Children's Science Center Charrette Summary Notes

Charette Date: Friday, November 14, 2014

Loudoun County Department of Economic Development

Drawing by Group Two:

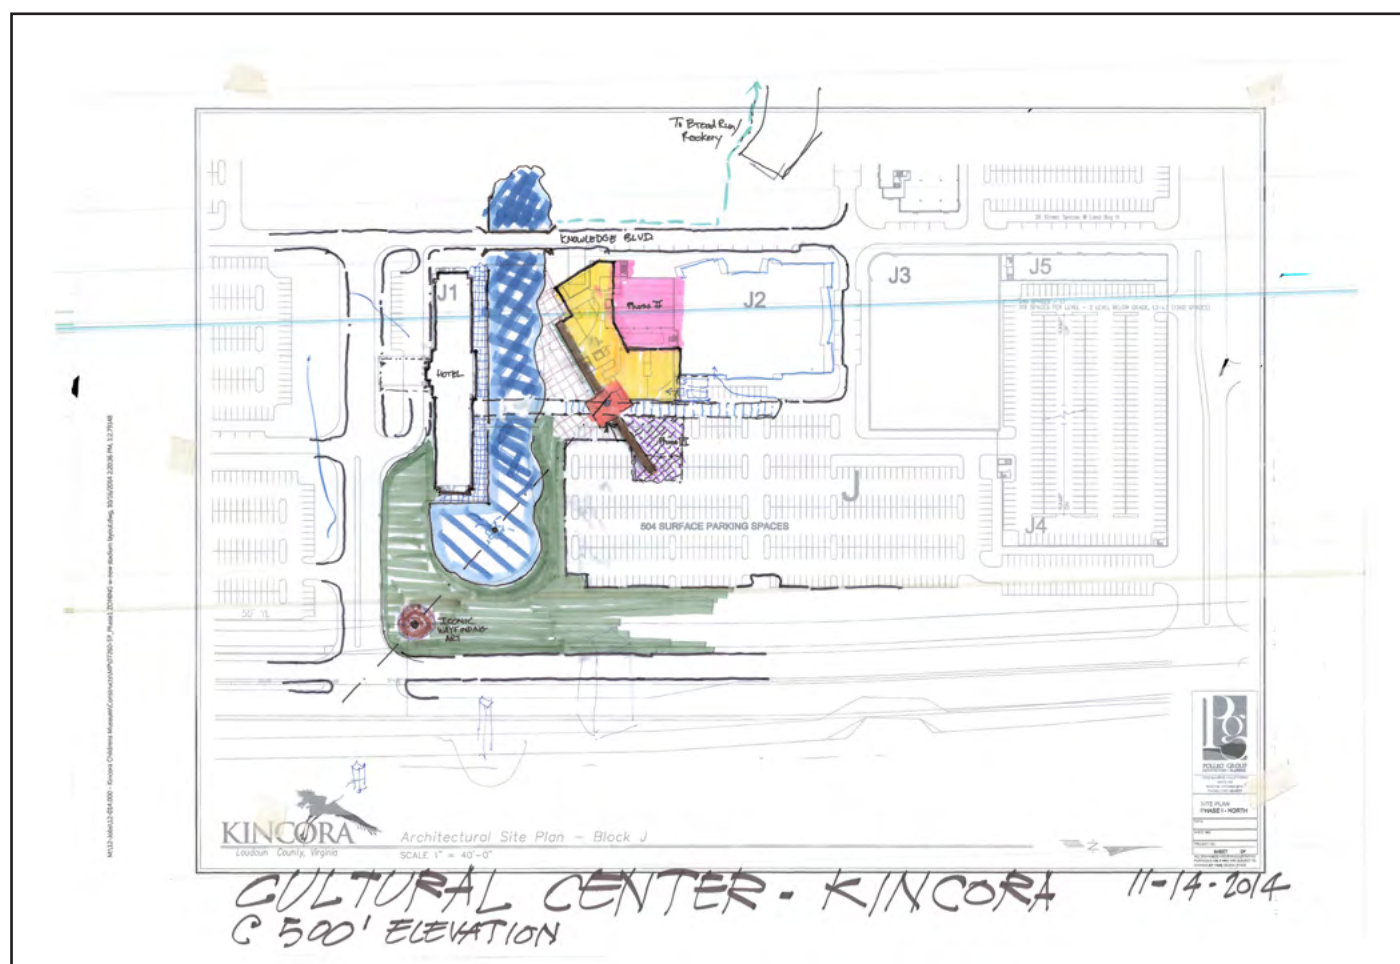
- It is Important to establish pedestrian connections to Broad Run from CSC. These connections should be well-defined and communicate ideas related to nature, science, technology, and sustainable development.

- Two linear pedestrian connections are drawn to connect to Broad Run. They would run along the outside edges of the Kincora Town Center with use still to be determined; the connection on the north side would be major, and south side would be minor.

- A section of the north side major pedestrian connection could function as a linear plaza/public space. The space drawn in pumpkin orange along part of the north connection to Broad Run would work well as a venue for small public events and non-permanent uses, such as a farmer's market. The buildings would need to be set back from the walkway to activate the space, encourage people to gather and potentially enjoy it as a "third place" to socialize.

- The long and open street, at the south side of the TBD space, could use strategies to slow down people who are arriving or passing on that road. Making it a pavers street with an architectural element would discourage cars from going there, or at least slowing their movement. The ordering of the space and elimination of curb and gutter can also provide a sense that the space is for pedestrians first; the design of this street is not focused on moving cars. This focus on pedestrians helps to activate the space. Similar strategies are used at Reston Town Center (especially Fountain Square) and National Harbor.
- Buses could be routed to the street for transit rider drop-off.

- As pedestrians enter the urban plaza, which is just south of CSC and on the north side of the hotel, the layout of the plaza draws them in and allows them to go right, left, or straight. There would be strong linking elements that connect the plaza to the STEM themes of CSC. These elements will bring the design together and call attention to other elements out in the plaza, which all work together to communicate the themes for the design. These elements would include sculptural elements that act as landmarks and therefore make it possible to tell someone to “meet me by the science tower” or “meet me under the tail of the whale” and such.

- To phase the building of CSC, there could be an expansion pod with elements linking it back to the hotel. On the hotel side of the plaza space there would be a hard edge with a bulkhead wall along with a water feature, with a hard edge promenade like the Carroll Creek Park in Frederick, Maryland. The other side of the water element is more of a natural soft-edged pond.

- The configuration of the Performing Arts Center and CSC should be switched. The Performing Arts Center does better at the corner spot because of the straight walls, which work with the hard edge at the street. CSC is better suited for being next to the natural/biomorphic soft edges of the water element.

- Parking would need to be reworked, but this switch should work fine with connecting to the minor and major pedestrian ways.
- The bridge over the water element could be like the Washingtonian Center in Gaithersburg. At sunrise and the sunset, the building will throw a lot of shadow, which makes the water element better suited for that space than trees or shrubs.

- The right in and right out for the parking lot flushes traffic back to Nokes – the primary road for accessing the CSC.

- The outdoor classroom would be located in the open space along Broad Run, directly across from a large area of natural open space.
- This location would be at a natural spot between the major and the minor pedestrian pathways, and the north-south pathway along Broad Run.
- In summary, CSC being located in the midst of other development at Kincora makes it especially important to consider how the nearby spaces could be designed to both activate the space and connect it to other nearby locations that relate to STEM, the nature and history of the site, and other places of interest for families, especially children. The ideas discussed for the plaza, paver street, and pedestrian connections out to Broad Run and the outdoor classroom respond to these considerations.

Drawing by Group Three:

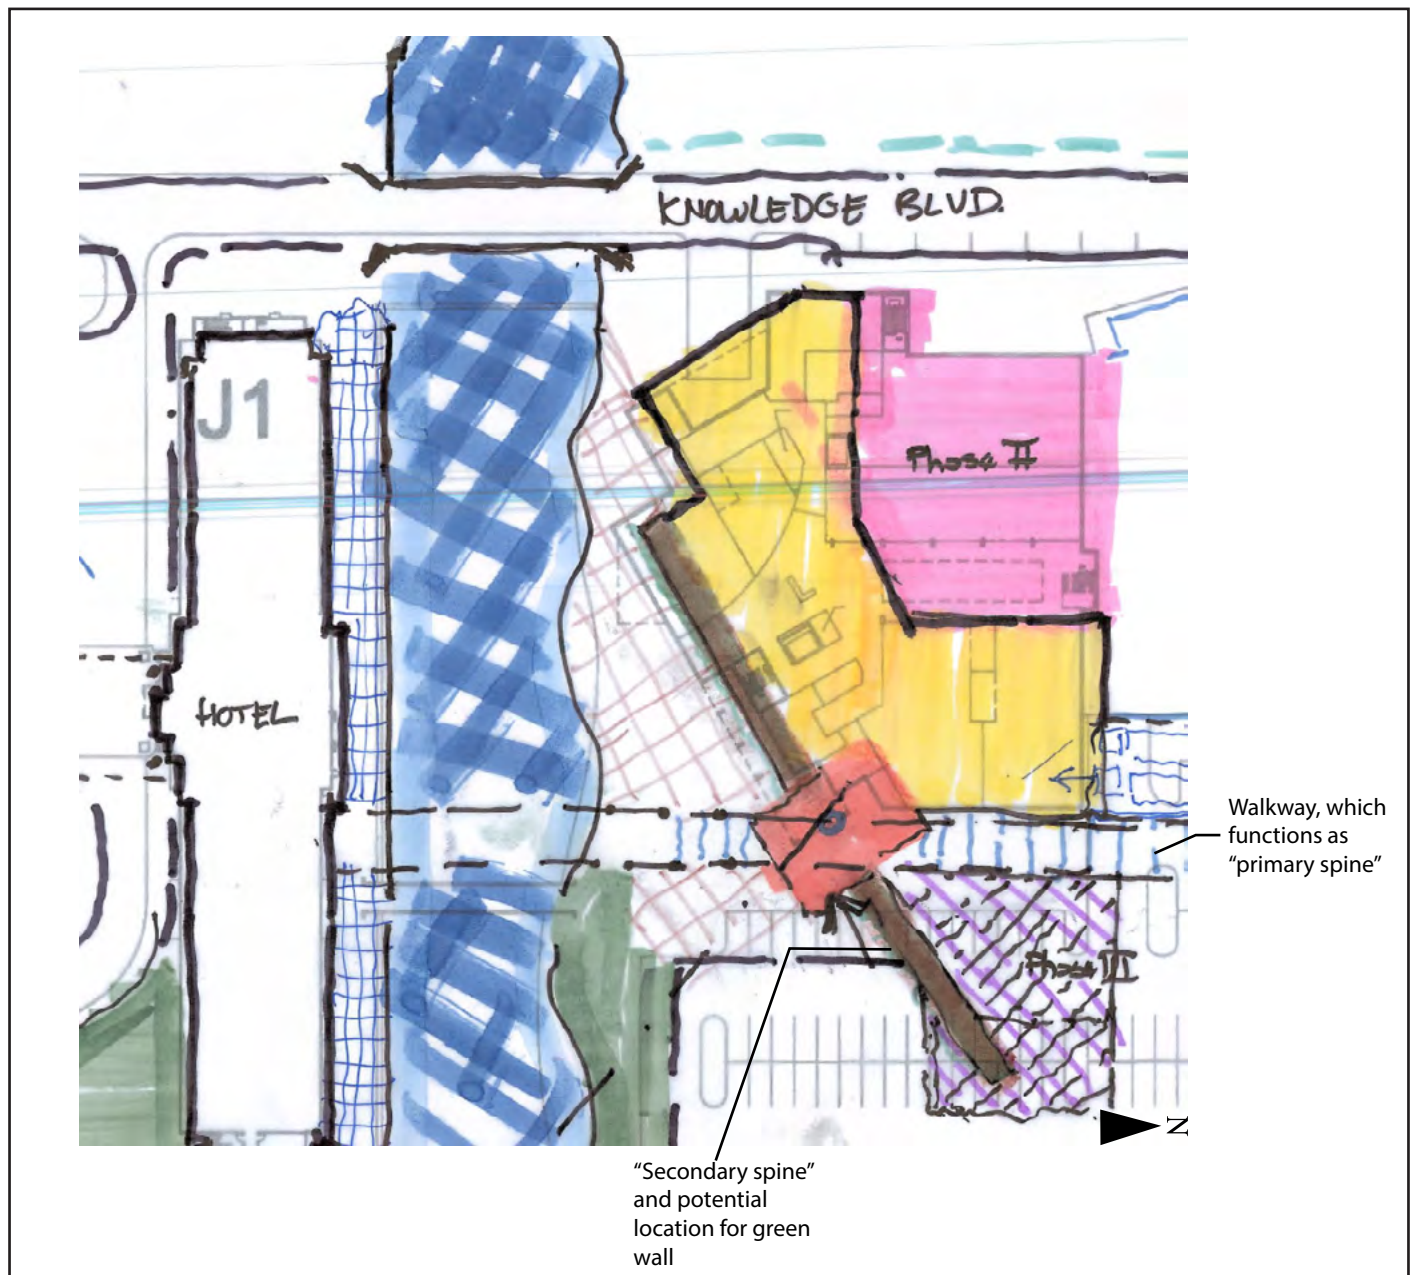
- Use a canal water feature to establish a visual cue and connection from CSC to Broad Run.
 - The pedestrian connection approaching the hotel from the north would look like a bridge, but not actually have open space hollowed out underneath - utilities would need to be routed through that spot.

- There could be a hard surface with a granite wall going down to the water on the side of the hotel, with a plaza hardscape leading up to the hotel. This would create a hard edge on the side of the canal with the hotel. On the side with CSC there would be more of a soft edge.

- There could be a covered walking space like a loggia leading up the bridge and hotel as one approaches from the north. This linear element would be a primary spine through the site and transition from the loggia to a covered internal walkway.

- There could be an atrium connecting the performing arts center and CSC, and the linear connection between them would be a secondary spine through the site.

- The area marked Phase II (see next page for close-up) could be a public space initially. It could be used as a temporary dynamic exhibit space, perhaps a "living exhibit" while CSC is being built.

- The design could communicate the essence of STEM using natural materials and biophilic principles of design. This is different from the way STEM typically has been communicated in the past, where design elements have had more of a technological futurist style; instead, CSC could incorporate the STEM connections in its design with nature. The diagonal secondary spine could have a green wall.

- There is a concern that the buildings for Phase 2 and 3 could cast shadows on inner areas of the CSC building or pedestrian areas. The minimum building height in the development is 2 stories; care should be taken to keep the CSC from having light and visibility shielded by the surrounding buildings.
